CONSUMERS POWER COMPANY

(Midland Plant, Units 1 and 2)

CONSUMERS POWER COMPANY'S ANSWER TO NRC STAFF INTERROGATORIES

(Dated 1/2/81)

BECHTEL ANN ARBOR		
MIDLAND POWER PLANT		
DEFINITION OF PARAMETERS INTERROGATORY 16		
	JOB NO. 7220	DRAWING NO. EXHIBIT 1
		REV. 0

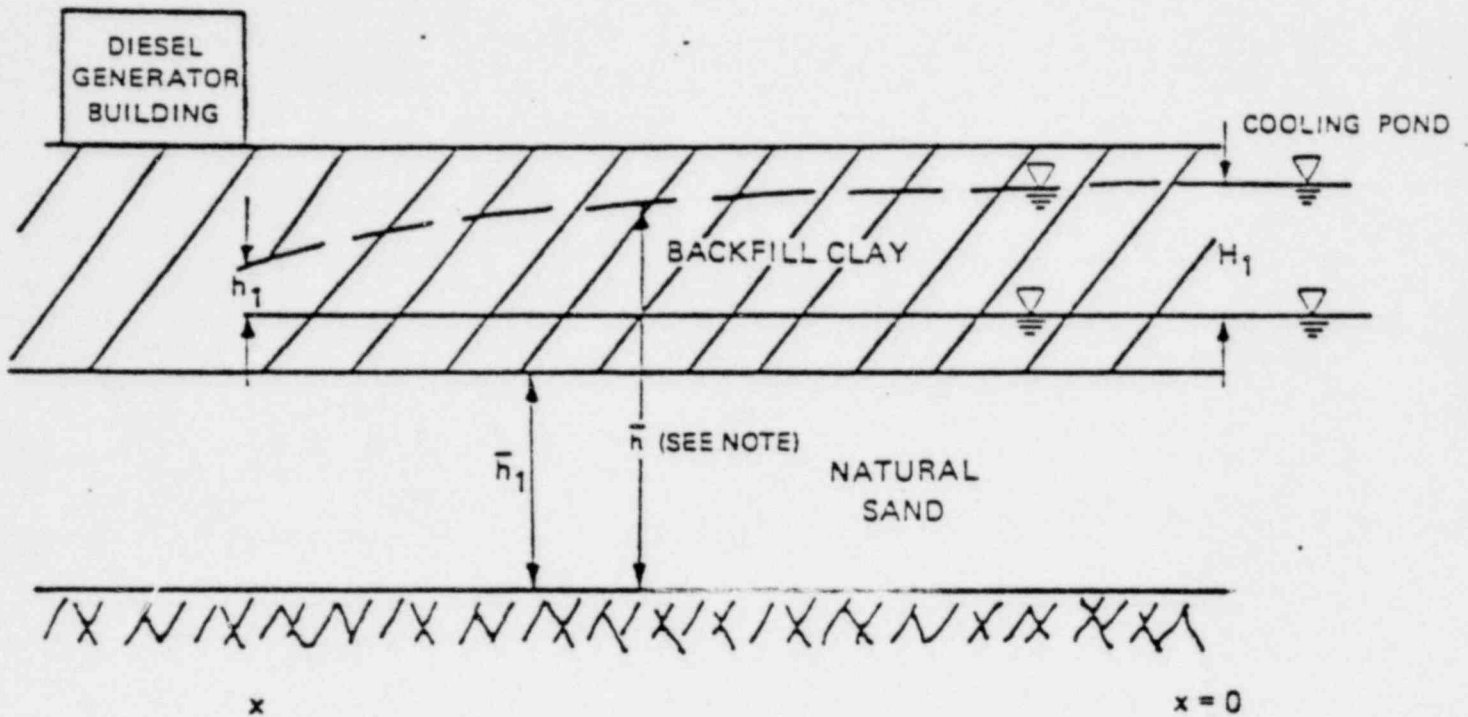
In your response to Request 24 concerning permanent dewatering, you used an error function equation to define water level rise. This equation 621642 as follows:

In Request 49, we asked for additional information on why 20 feet had been used for h when \bar{h} is defined as the average depth of water. Your response to Request 49 was that the values of h and H are much smaller because they represent the changes in head above the original potentiometric surface while the value of \bar{h} is the thickness of natural sands through which the seepage from the cooling pond is assumed to flow.

The equation that you used to model groundwater flow, from Bear, 1972, assumes a horizontal impervious bottom as a datum from which the terms h , H and \bar{h} are measured. It is not clear why you are using one datum, i.e., the original potentiometric surface (approximately 622 feet) to measure h and H and another lower datum (approximately elevation 607 to measure \bar{h} .

Have you performed any studies or do you know of the existence of any studies done using a single datum from which to measure h , H and \bar{h} ? If yes,

Provide your justification for using two different datums and show that your resultant groundwater rebound time is at least as conservative as the rebound time would be if computed using a single datum as in Bear, 1972.

A single reference plane from which to measure h , H and \bar{h} is discussed in Bear, 1972. The justification of the use of the two reference planes is presented below. This is followed by a discussion explaining the choice of the natural sand thickness to represent the average depth of flow.

Two reference planes were used in the equation given in response to NRC Question 24 to provide a more simplified description of the actual physical conditions. It can be shown that this formulation is equivalent to the one obtained using the approach taken by Bear 1972, in Paragraph 8.4.1, Example 1.

The above variables are shown on Exhibit 1, while the variables h , H , H_0 , and D refer to Figure 8.4.1 of Bear, 1972.

Thus, Equation (3) which assumes two reference planes, is equivalent to Equation (2). The results obtained with both equations will then be identical.

The approach used in the numerical application differs from that derived from Bear 1972, in the use of \bar{h} , the average depth of flow. In our response, \bar{h} was redefined to represent the thickness through which flow occurs, \bar{h}_1 , as shown on Exhibit 1. Because of the large difference in permeabilities between the backfill clay (see Figure 24-5, in response to NRC Question 24) and the natural sands, effectively no flow would take place through the backfill clays.
